PARRAMATTA POWERHOUSE (SSD-10416)

**Submission made on behalf of the
landowners of 32 Phillip Street, Parramatta**

EXECUTIVE SUMMARY

Figure 10 – Site Plan – Civic Link

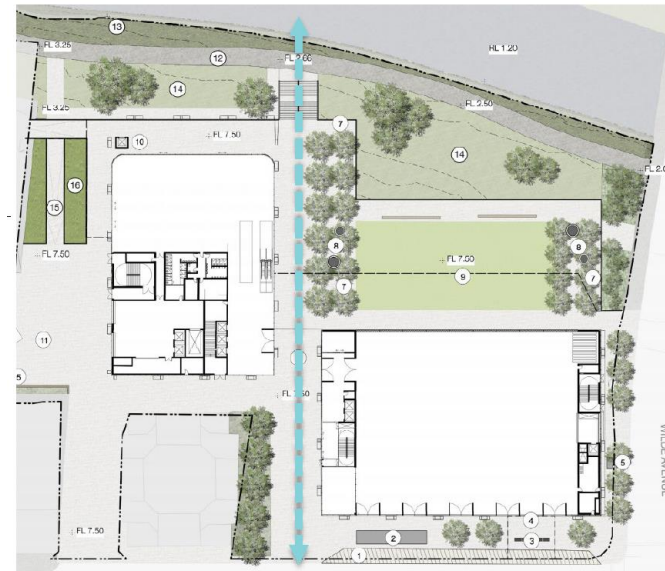
The proposed levels in the landscape documentation and indicated on the architectural documentation seek to lift the level of the ground plane from a current RL 6.7 along our northern boundary to RL 7.5.

This design strategy means the Civic Link will rise 1m across the length of the east and west boundaries from its current levels. The implications of this design strategy include reworking of the loading dock levels, car park ramp levels and potential conflicts with the ability to open up and activate the Civic Link along the eastern frontage of the subject site.

Figure 13 - Preferred landscape treatment of Civic Link optimising potential for activation

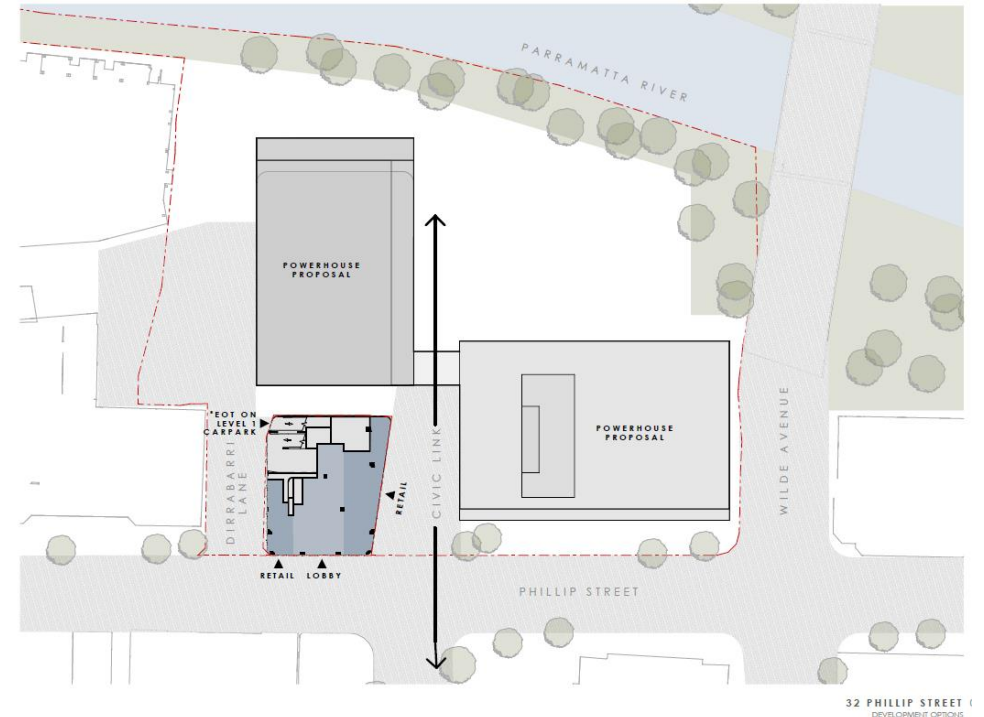
Concern is raised in relation to the proposal to retain dense vegetation along the western boundary of the PPM site adjoining the subject site, as this will not provide any potential to activate the western side of the Civic Link, including active uses with outdoor dining opportunities on the ground floor of the subject site.

2. The PPM project team should be requested to clarify the proposed landscape treatment for the Civic Link.
3. The landscape treatment on the western side of the Civic Link should allow for ground level use of the 32 Phillip Street site to include active uses that address and make the most positive contribution to activating the Civic Link.

4. The landscape treatment of the Civic Link should be open to allow pedestrian movement and visual connections between buildings on both sides of the Civic Link.
5. The landscape solution for the PPM should provide for outdoor dining opportunities including licenced areas along the western edge of the Civic Link fronting the 32 Phillip Street site.

Figure 2: 5% AEP Flood Levels and Depths

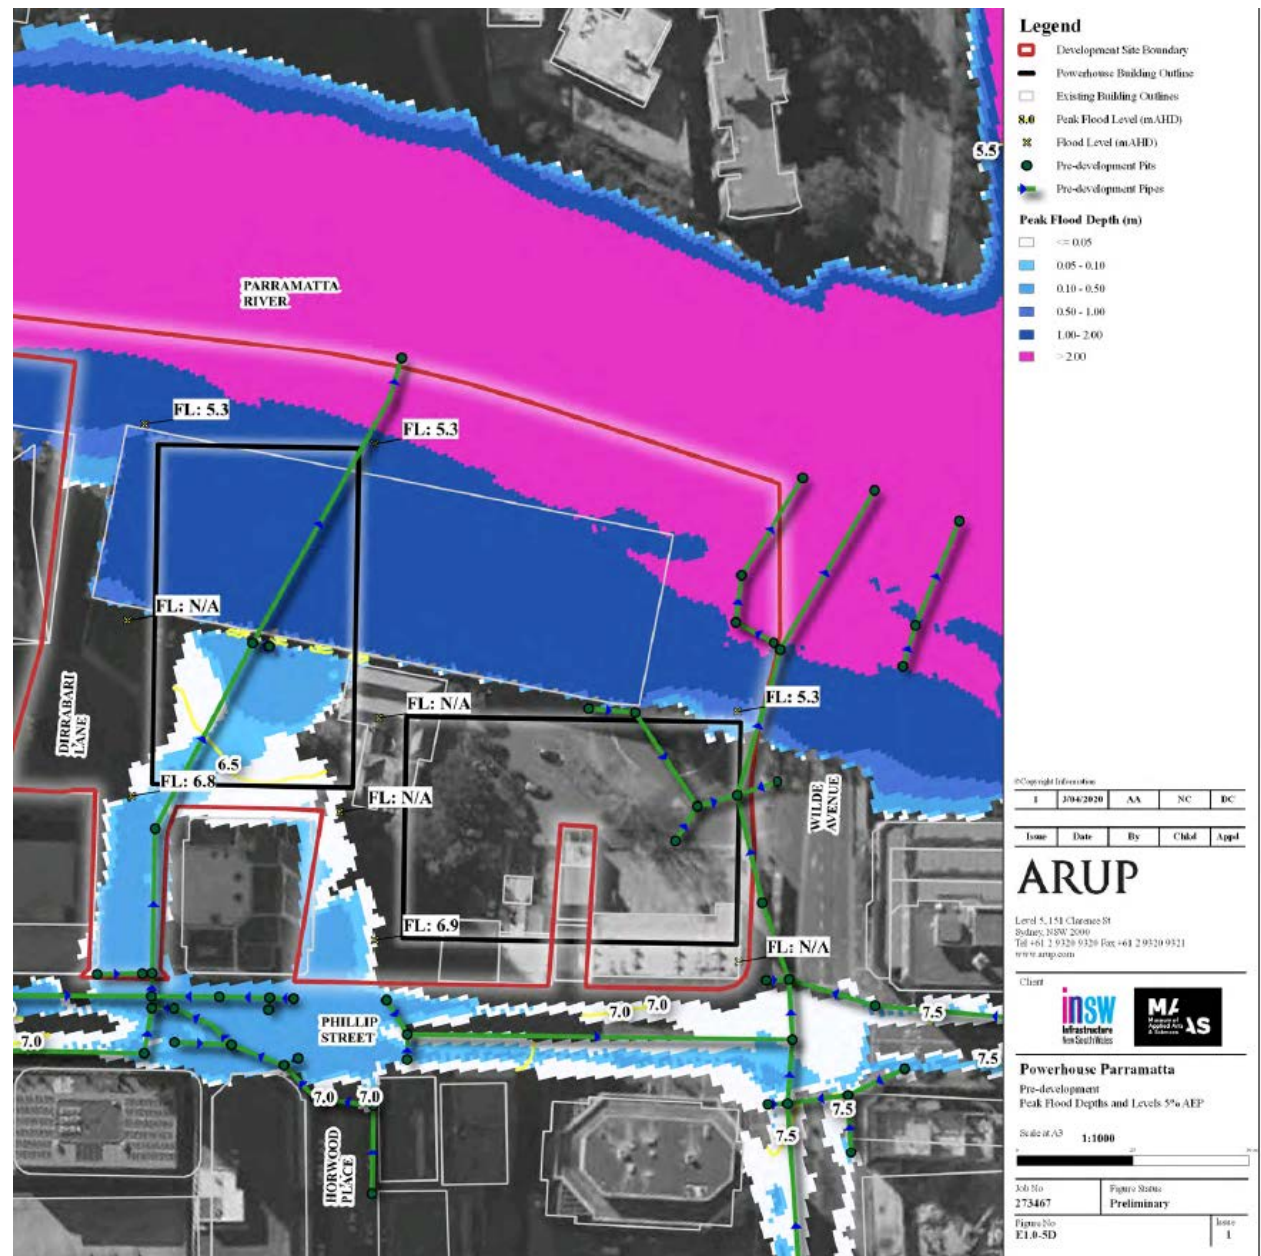
Figure 2 shows that even in a 5% AEP overland flow event the underground pipe network is unable to take all of the flows. Because Dirrabarri Lane and Willow Grove are slightly higher than Phillip St, the water ponds in Phillip St. Once it has reached sufficient depth it flows around either side of 32 Phillip Street and into the at-grade car park at its rear. This is what happened on 9th February, 2020 and floodwaters entered the foyer of 32 Phillip Street.

It could be ponding up to 0.5m deep at the front of the building in a 5% AEP event. In the 1% AEP flood the water depths in front of 32 Phillip Street would be a little deeper. In the PMF the water could be up to 4.5m deep in front of 32 Phillip Street but this would be mainly controlled by the flood level in the Parramatta River which would only be about half a metre lower.

Figure 3: Proposed Design Responses to Manage Overland Flows

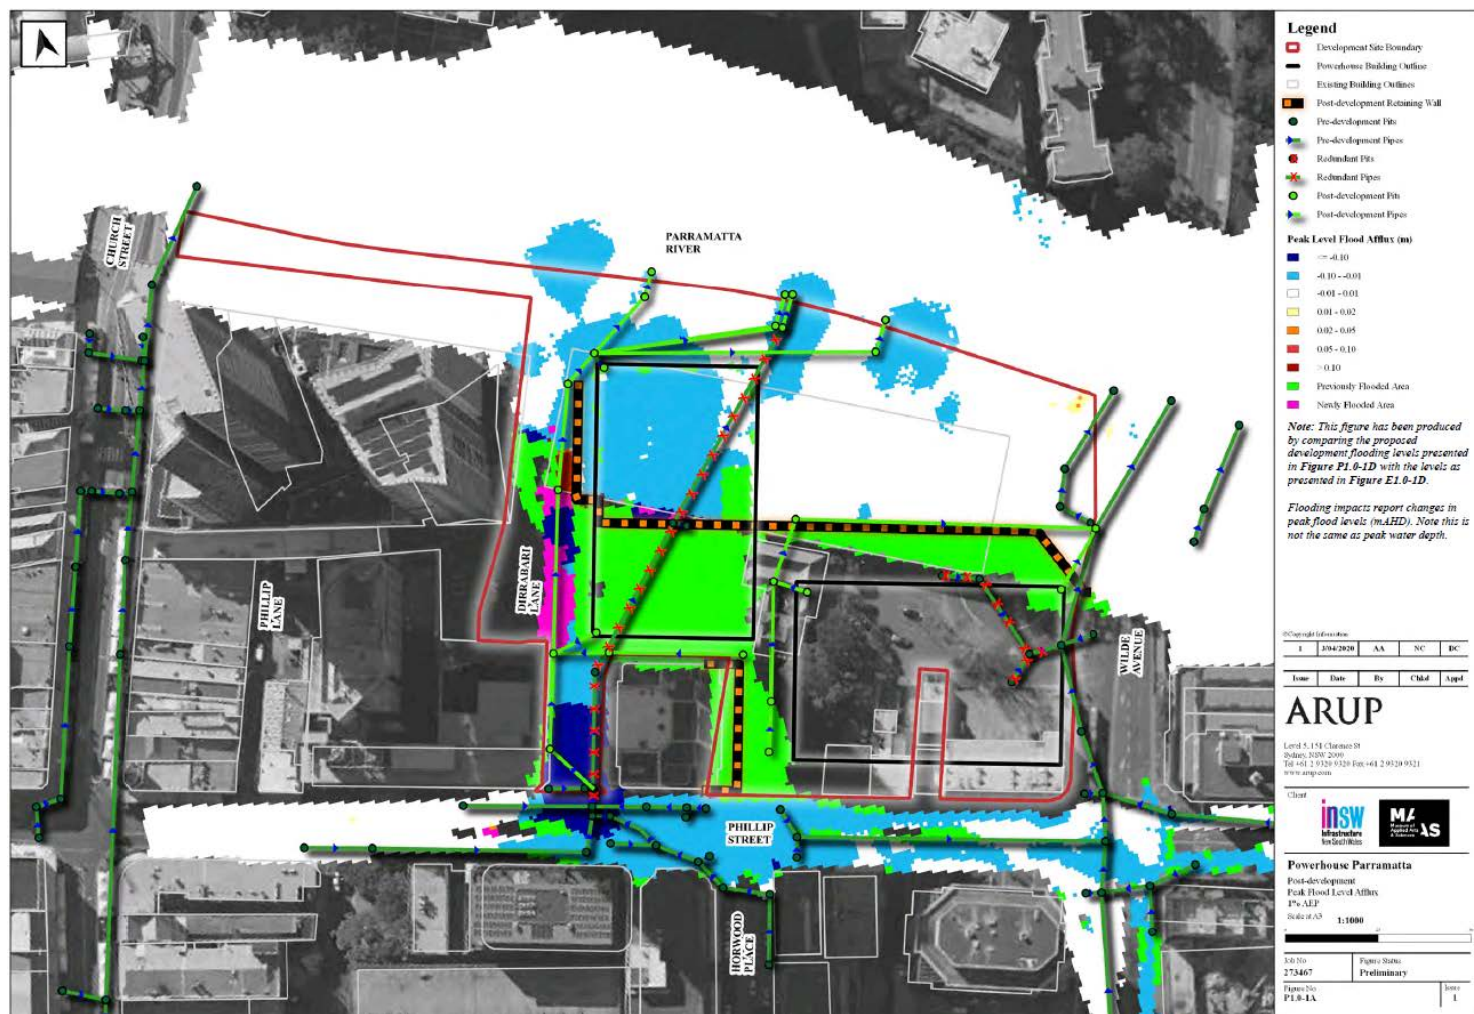
The overland flow management strategy for the PPM is to increase the capacity of the pipe in Dirrabirra Lane and to provide a new pipe to take overland flows along the eastern side of the subject site. This will effectively increase the flow rate underground and reduce the flow rate overland. Molino Stewart are concerned that if the inlets to the pipes are 100% blocked then they will make no contribution to flood conveyance and will not reduce flood levels at the subject site. As it is proposed to increase the ground levels to the east of the subject site and if Dirrabirra Lane is increased in level, then overland flow water will need to pond to a higher level in Phillip Street and increase the flood levels for the subject site.

Figure 3 shows how the museum development proposes to manage overland flows and the impacts on overland flows in a 1% AEP event.. The existing 600mm diameter pipe which currently runs under Dirrabarri Lane and the multideck carpark will be replaced by a 1200mm diameter pipe running under Dirrabarri Lane and heading directly north to the river. Then on the eastern side of 32 Phillip Street a new 600mm pipe will be laid to take water directly to the river between the two museum buildings.

As can be seen in Figure 3, these measures would eliminate flooding to the immediate east and north of 32 Phillip Street and slightly reduce levels in Phillip Street and Dirrabarri Lane in a 1% AEP event.

Therefore, to protect the commercial interests of the owners of 32 Phillip Street, it is recommended that:

Figure 2.4.1 Phillip Street work zone and Site boundary hoarding

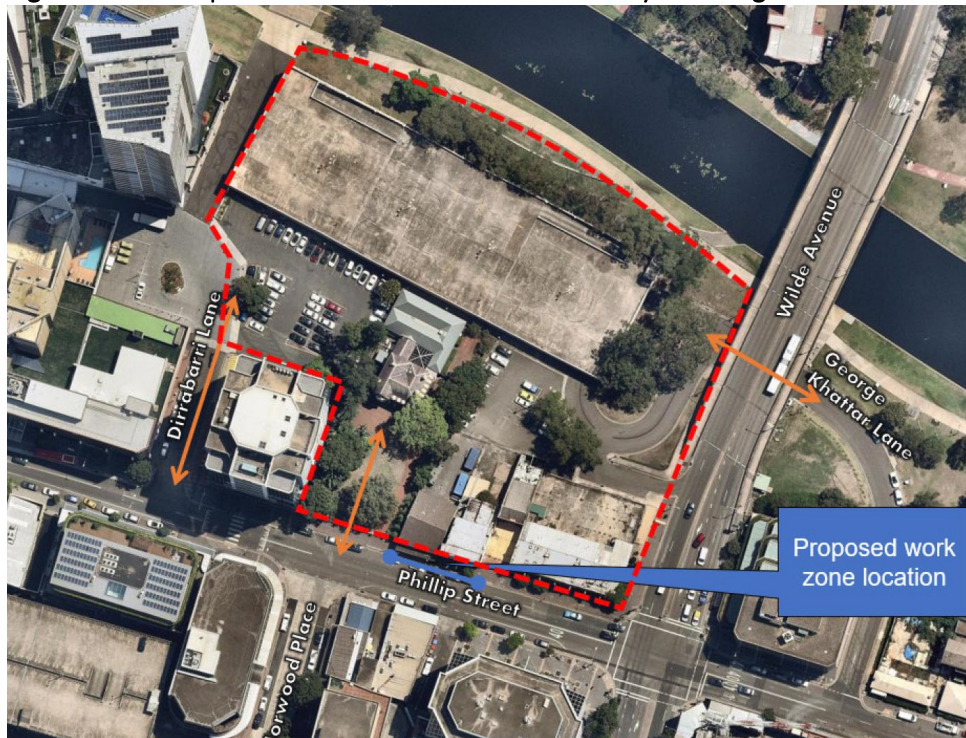
Figure 6 in Aver's CMP and Figure 2.4.1 below sourced from JMTs Transport Impact Assessment illustrates the location of the proposed work zone in Phillip Street (shown in blue) and the perimeter site boundary hoarding (shown dotted red).
